SUNDRY NOTICES AND REPORTS ON WELLS

8. Well Name and No.
Chaco 23-08 3

Energgen Resources would like to make the following changes to the Chaco 23-08 3 #1H.

Drilling Plan
Energen Resources Corporation
Revised 10/13/15

Plan: APD Plan #2

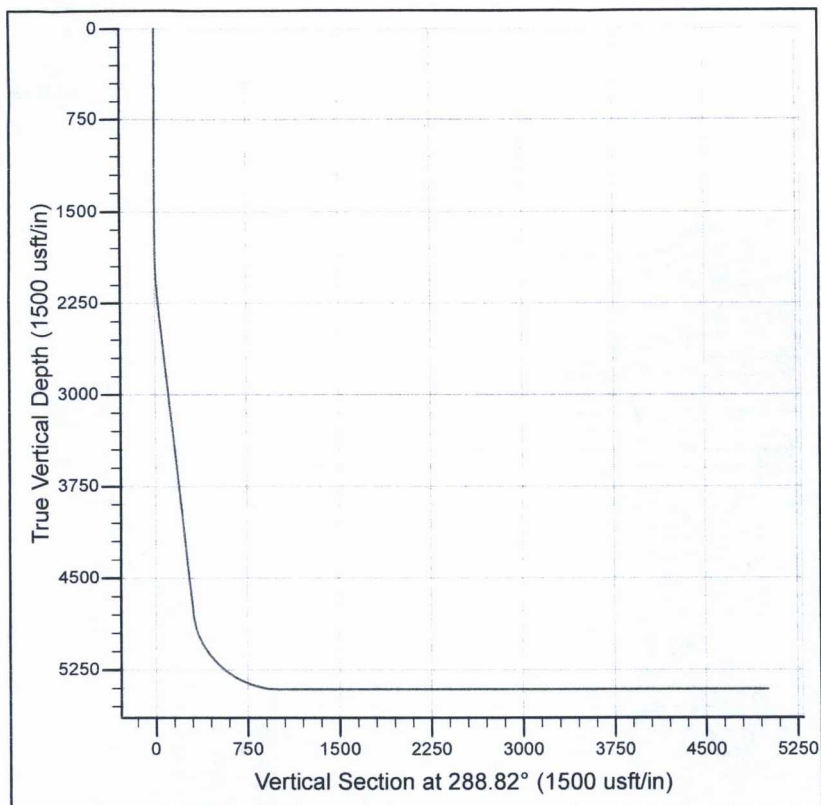
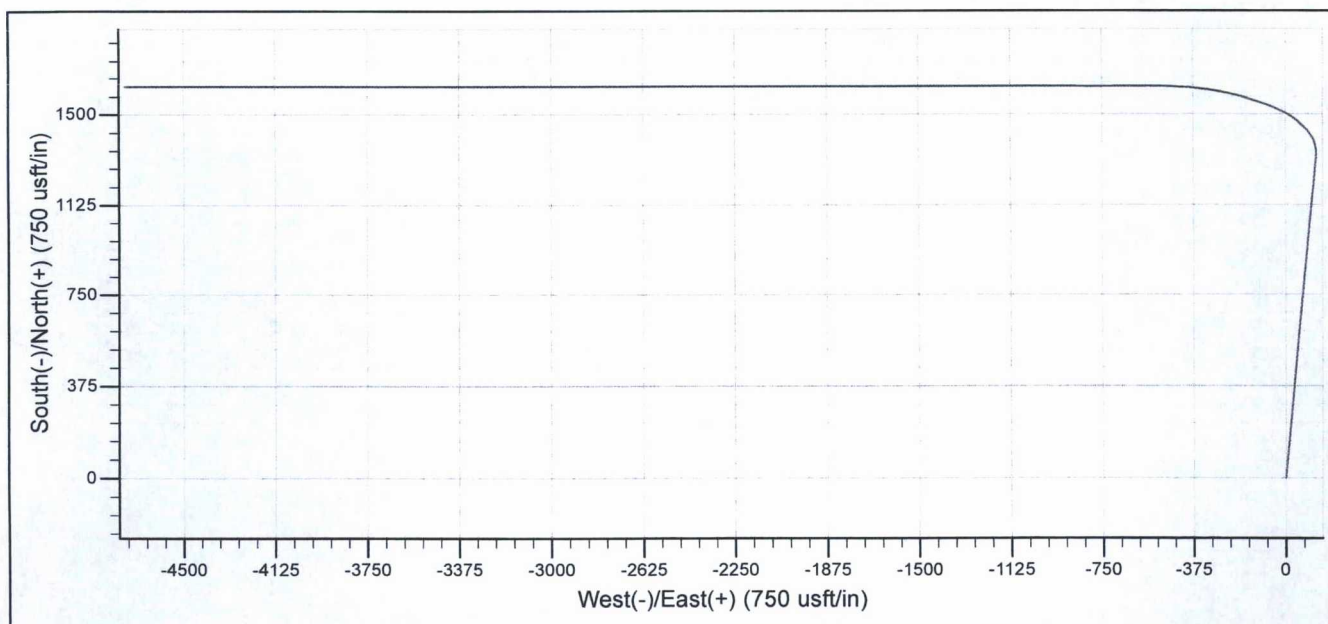
Change the set depth of the 9-5/8" surface to 320' (MD); 320' (TVD) and decrease the cement volume to 190 sks.

Change the set depth of the 7" intermediate to 6150' (MD); 5416' (TVD) and decrease the cement to 646 sks followed by 90 sks.

Change the set depth of the 4.50" production liner to 10360' (MD); 5416' (TVD) w/TOC @ 5950' (MD) and decrease the cement volume to 400 sks. Change the hole size from 6-1/4" to 6-1/8".

The revised drilling and directional plans are attached.
